2.0 SITE CHARACTERISTICS

2.5 Geology, Seismology, and Geotechnical Engineering

NRC staff performed an extensive review of Fermi 3 COL FSAR Revision 5 Section 2.5, interacted with the applicant on many occasions through public meetings; and requested additional information to substantiate and support the applicant’s conclusions in the FSAR. Because of the Fukushima Dai-ichi nuclear power plant accident after the Great Tohoku earthquake and the subsequent tsunami in Japan in 2011, the NRC issued an information request letter dated March 12, 2012, requesting all operating nuclear power plants in the U.S. to re-evaluate seismic hazards using the most recent information and methodologies available. The NRC Near-Term Task Force (NTTF) issued a series of recommendations for improving nuclear power plant safety in the U.S. following the Fukushima Dai-ichi accident. The information request letter stated that nuclear power plant sites in the CEUS will be able to use the newly published seismic source model in NUREG–2115, “Central and Eastern United States Seismic Source Characterization for Nuclear Facilities,” to characterize seismic hazards related to their plants. Following the issuance

Figure 2.5.1-3 Fermi 3 Site Region Map of Tectonic Structures
 (Reproduced from Fermi 3 COL FSAR Figure 2.5.1-203)

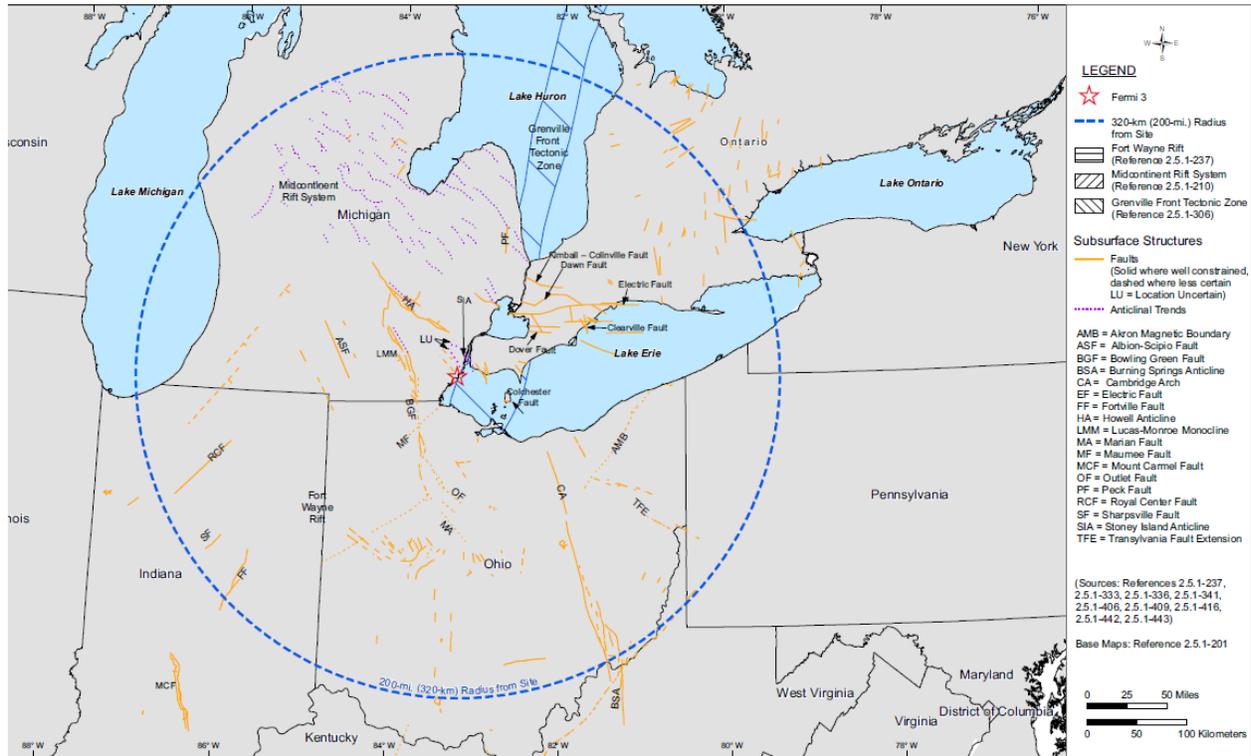
In RAI 02.05.01-24, the staff asked the applicant to describe the three faults depicted in FSAR Figure 2.5.1-203 but not described in the FSAR text. In the response to RAI 02.05.01-24 dated February 11, 2010 (ML100570306), the applicant explained that the Outlet and Marion faults are part of the Bowling Green fault zone that the applicant described in FSAR Subsection 2.5.1.1.4.3.2.3. The Bowling Green fault zone is located approximately 40 km (25 mi) from the Fermi site at its closest point. There is no evidence of Quaternary age faulting along any of the

faults within the Bowling Green system. The applicant revised FSAR Subsection 2.5.1.1.4.3.2.3 to differentiate the different faults in the Bowling Green fault zone.

Also in the response to RAI 02.05.01-24 is the applicant's revision of the FSAR to include a description of the Colchester fault. The Colchester fault shows no evidence of Quaternary geologic faulting. The staff reviewed the applicant's response to RAI 02.05.01-24 and concluded that the applicant has adequately evaluated all known potential fault sources in the Fermi site region based on the most current geologic literature. Following the applicant's response to RAI 02.05.01-24 and the applicant's revision to FSAR Subsection 2.5.1.1.4.3.2 and FSAR Table 2.5.1-201, the staff concluded that the applicant has provided an adequate discussion of known geologic faults in the Fermi site region. Therefore, RAI 02.05.01-24 and RAI 02.05.01-07 are resolved and closed.

Figure 2.5.1-5 Photographs of Strata in the Denniston Quarry, Monroe, Michigan.
 Note: A. Exposure of paleokarst feature in the Bass Islands Group and disrupted bedding beneath the feature.
 B. Insert of disrupted bedding beneath paleokarst feature.]

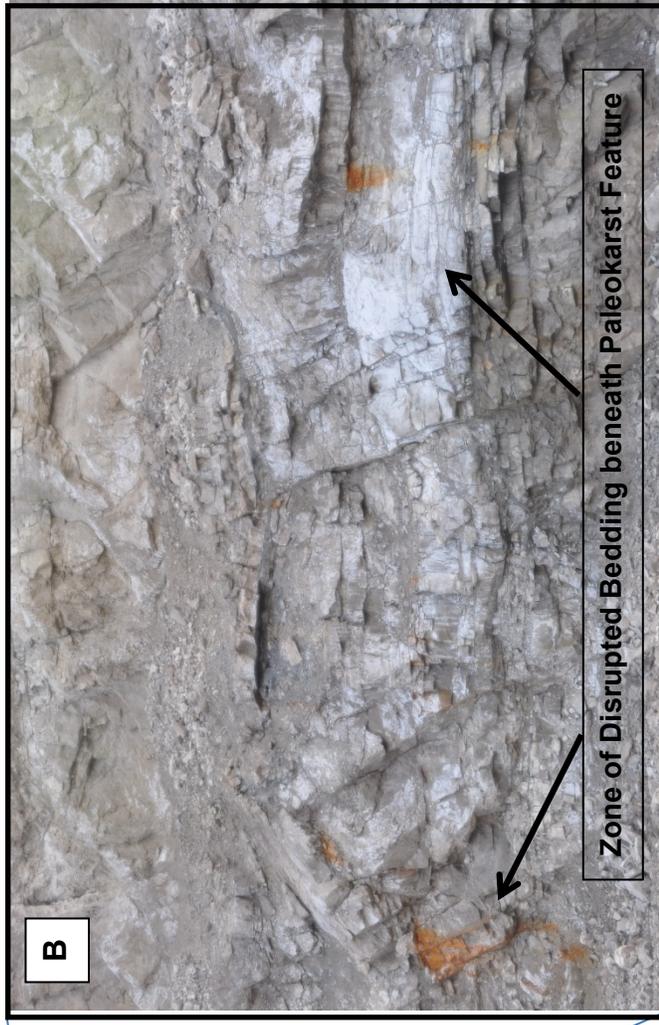
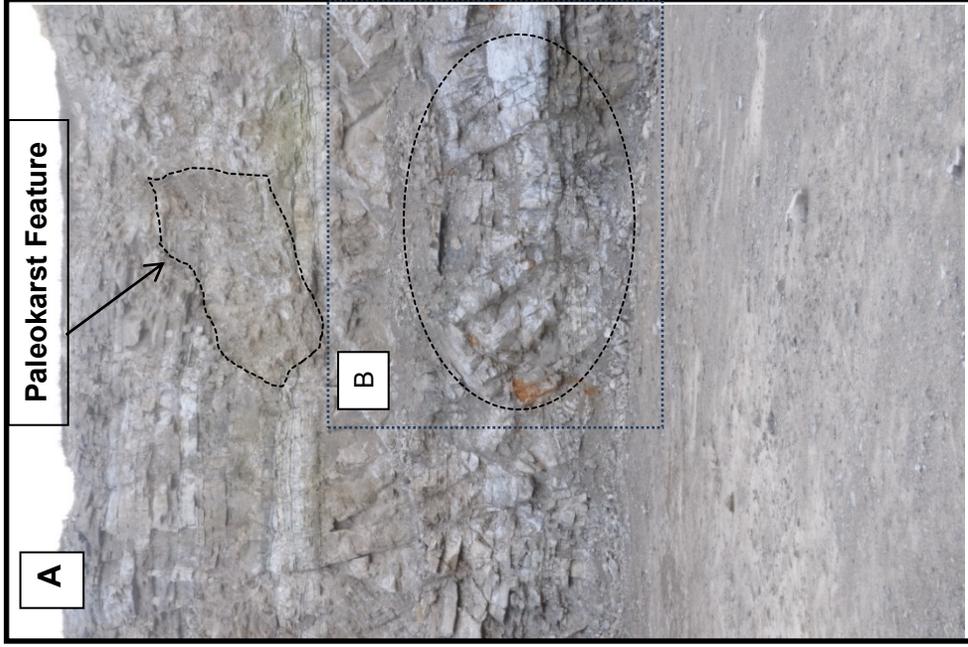
During the NRC staff's visit to the Denniston Quarry in Monroe County, Michigan, as part of a November 2009 Fermi 3 COL site audit, the staff noted at least three zones of disrupted bedding exposed in the quarry walls. These disrupted zones suggest possible faulting of the Bass Islands Group. In one location, disrupted bedding exists beneath an interpreted paleokarst feature (located near the top of the geologic section) and suggests that the paleokarst development may be associated with faulting at depth. Figure 2.5.1-5 in this SER shows this paleokarst feature above a zone of disrupted bedding in the Bass Islands Group. In a second quarry location, a zone of disrupted bedding exists with mostly undisturbed bedding on either side. This second zone appears to be at least seven to ten meters wide; contains disrupted bedding from the top to the bottom of the exposed wall; and is flanked by relatively undisturbed bedding on both sides. The third zone of possible disturbed bedding was visible in a distant wall and could be related to vertical offsets within the Bass Islands Group.

Figure 2.5.2 -8 Earthquakes with Magnitudes Equal to or Greater than 3.0 in the CEUS between 2009 and 2012

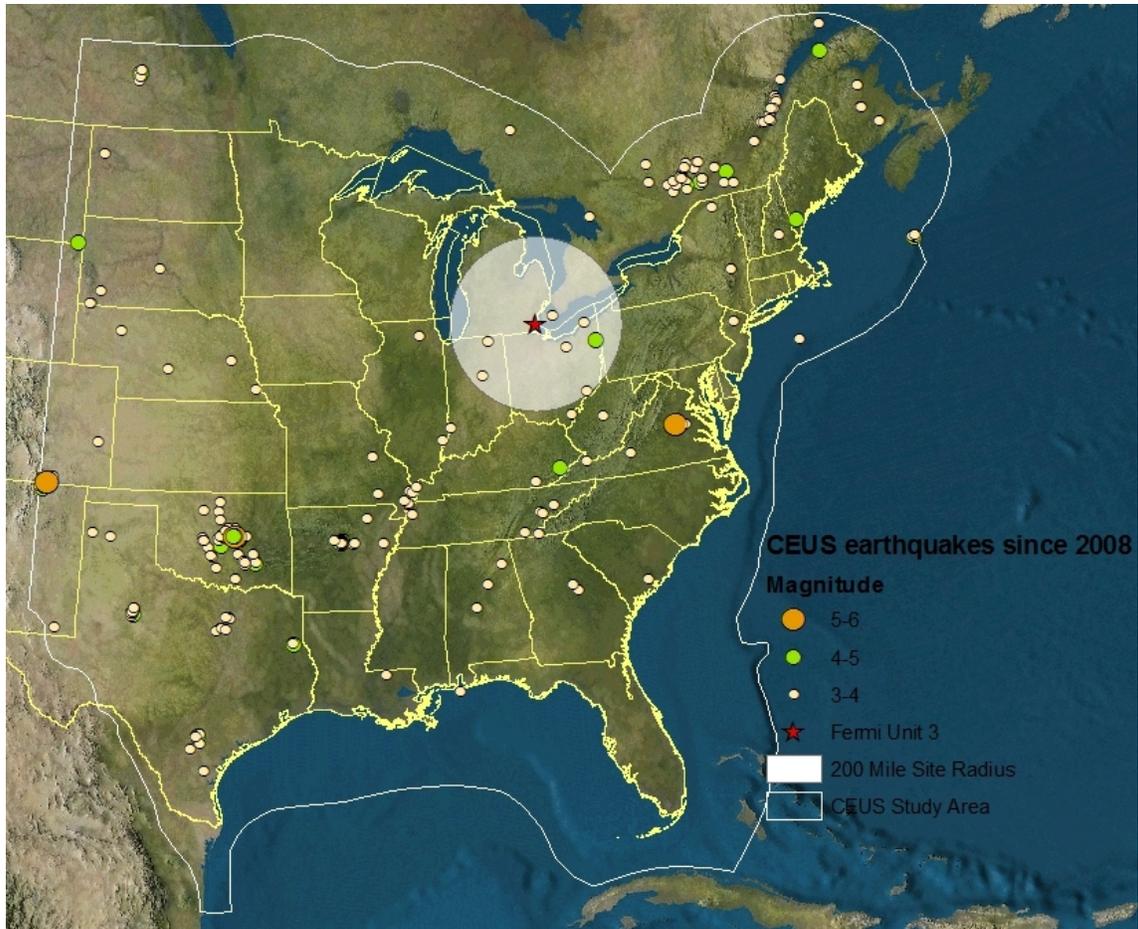
The staff developed a supplementary earthquake catalog covering the CEUS region from 2009 through 2012, in order to evaluate the completeness of the applicant's updated catalog and subsequent conclusions. The staff used the USGS ANSS, which is in Figure 2.5.2-8 in this SER. The staff compared this recent seismicity with the applicant's updated catalog in FSAR Figures 2.5.2-202 and 2.5.2-203. The staff concluded that the recent seismicity does not show any significant deviations from the applicant's updated seismicity catalog. Therefore, the staff concludes that the Fermi 3 earthquake catalog adequately characterizes the regional and local seismicity through 2012.

Figure 2.5.2-9 Plot Comparing the Staff's and the Applicant's 1-Hz Total Mean Hazard Curves for the Distributed Seismicity Source Zones

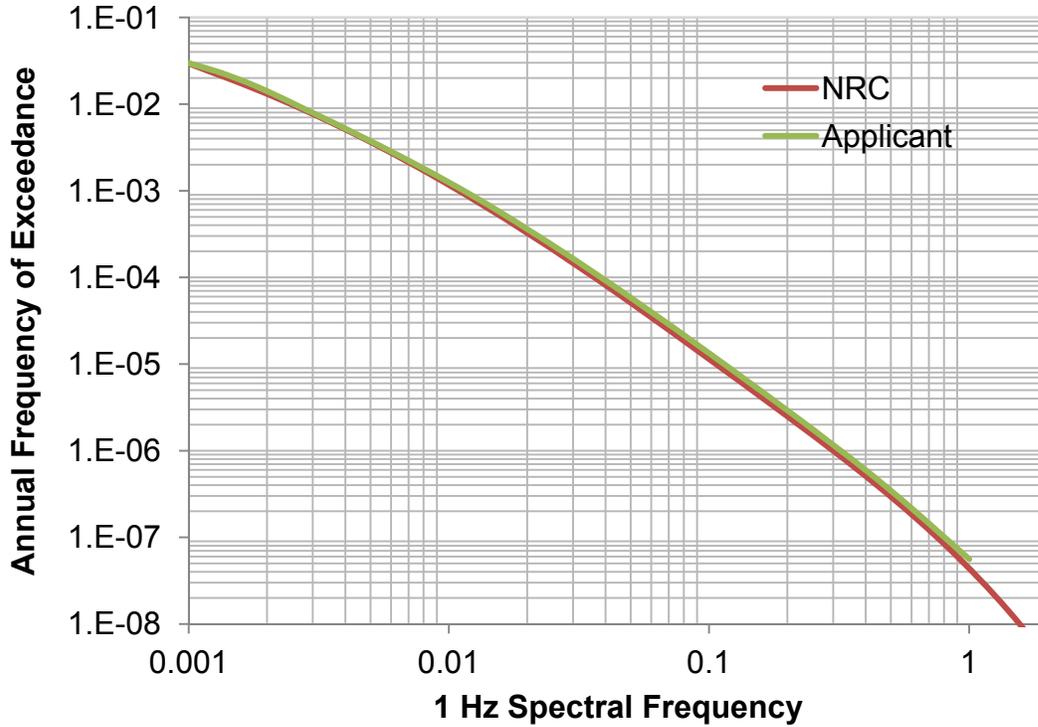
To determine the adequacy of the applicant's PSHA calculations, the staff performed its own confirmatory PSHA calculation for the Fermi 3 site. The staff used the CEUS-SSC model (NUREG-2115) along with the EPRI (2004, 2006) GMM. The staff conducted the PSHA for the Fermi site using a source distance radius of 1,000 km (620 mi) for the CEUS-SSC-distributed seismicity sources. The staff's calculation did not include the RLME source zones. Therefore, the staff compared its confirmatory 0.5, 1, 2.5, 5, 10, 25, and 100 Hz hazard curve results with the applicant's results for the distributed seismicity sources and determined that the two sets of results are almost identical. This finding is illustrated in Figures 2.5.2-9 through Figure 2.5.2-11 in this SER showing the PSHA hard rock hazard curve results for 1, 10, and 100 Hz, respectively, for the distributed seismicity sources.

Based on the above assessment, the staff concluded that the applicant's PSHA calculations adequately characterize the seismic hazard at the Fermi 3 site in terms of the contribution from the distributed seismicity sources. Because the staff's calculation did not include the RLMEs, the staff determined that the applicant had selected the appropriate RLME sources (i.e., the NMFS, WA, CHV, and CHS) based on their contribution of 1 percent or greater to the total mean hazard.

Figure 2.5.2-12 Comparisons of the Staff's Site Response Amplification Functions with the Amplification Functions Determined by the Applicant

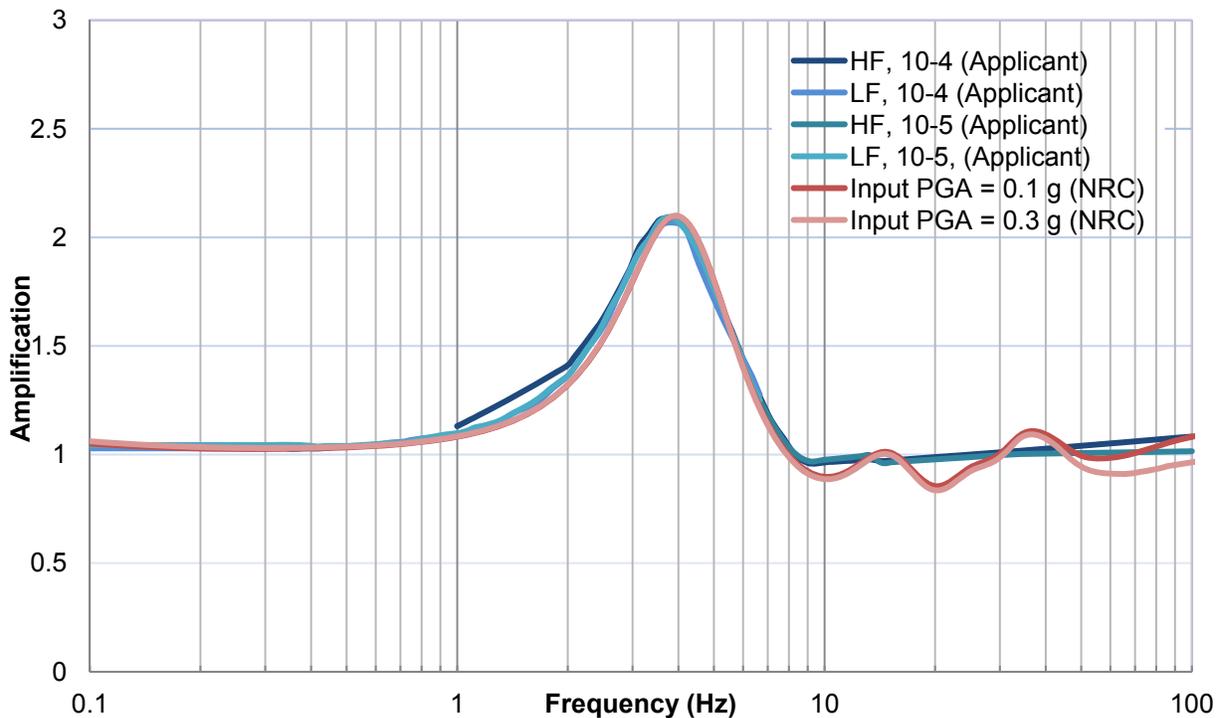
To determine the adequacy of the applicant's site response calculations, the staff performed confirmatory site response calculations. As input, the staff used the static and dynamic soil properties in FSAR Section 2.5.4 and summarized in FSAR Table 2.5.2-213. The staff performed site response calculations using the RVT methodology with 7 spectral frequencies and 11 input rock amplitudes. The use of RVT in site response calculations is mentioned in RG 1.208 as an acceptable alternative to the time series approach. The staff's site amplification function results are compared with the applicant's results in Figure 2.5.2-12 in this SER.

As Figure 2.5.2-12 in this SER shows, the applicant's amplification functions are similar to the staff's confirmatory calculations; and the very small difference observed between ~1 and 100 Hz are within the limits of uncertainties. Similar to the applicant's results, the staff's confirmatory calculations also show that the Fermi 3 site response is not strongly sensitive to the level of input motion. Figure 2.5.2-12 also shows that there are only small differences in the site amplification (at frequencies greater than ~40 Hz) using input PGAs of 0.1 g and 0.3 g.

Figure 2.5.2-13 Comparisons of the Staff's Site Response Amplification Function Using Damping Values Selected by the Applicant with the Staff's Site Response Amplification Functions Based on a Q_s of 40 and also Using a Correlation Model for USGS Category A

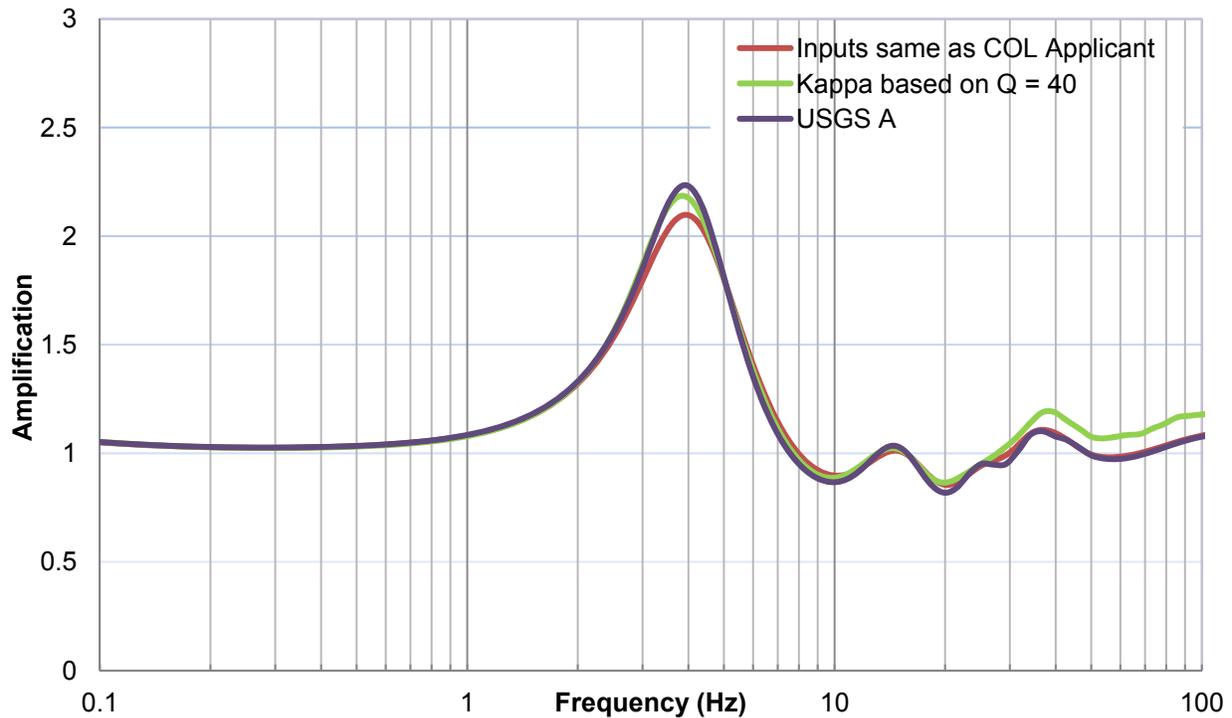
In addition to confirming the applicant's calculations, the staff conducted an additional sensitivity calculation to confirm the applicant's selected damping values in FSAR Table 2.5.2-214. Figure 2.5.2-13 in this SER compares the staff's amplification functions calculated using the applicant's damping values, with the staff's amplification functions calculated assuming a shear-wave quality factor, Q_s , of 40. Because the average S-wave velocity of the material above an elevation of 48 m (156 ft) is 1,737 m/s (5,700 fps), and the thickness of these materials is only ~121 m (396 ft), the kappa contributed by the profile can be computed by assuming a Q_s of 40 according to EPRI Report 1025287, "Seismic Evaluation Guidance," (EPRI 2012). As illustrated in Figure 2.5.2-13 of this SER, the staff's amplification functions calculated by assuming a Q_s of 40 is only slightly higher than the staff's calculated amplification functions that used the damping values developed by the applicant between frequencies of ~3 to 5 Hz and at frequencies above 30 Hz.

The staff's results are slightly higher than the applicant's at frequencies between 3 and 5 Hz. However, these differences are less than 10 percent.

Based on the above assessment, the staff concludes that the applicant's site response calculations adequately characterize the Fermi 3 site effects.
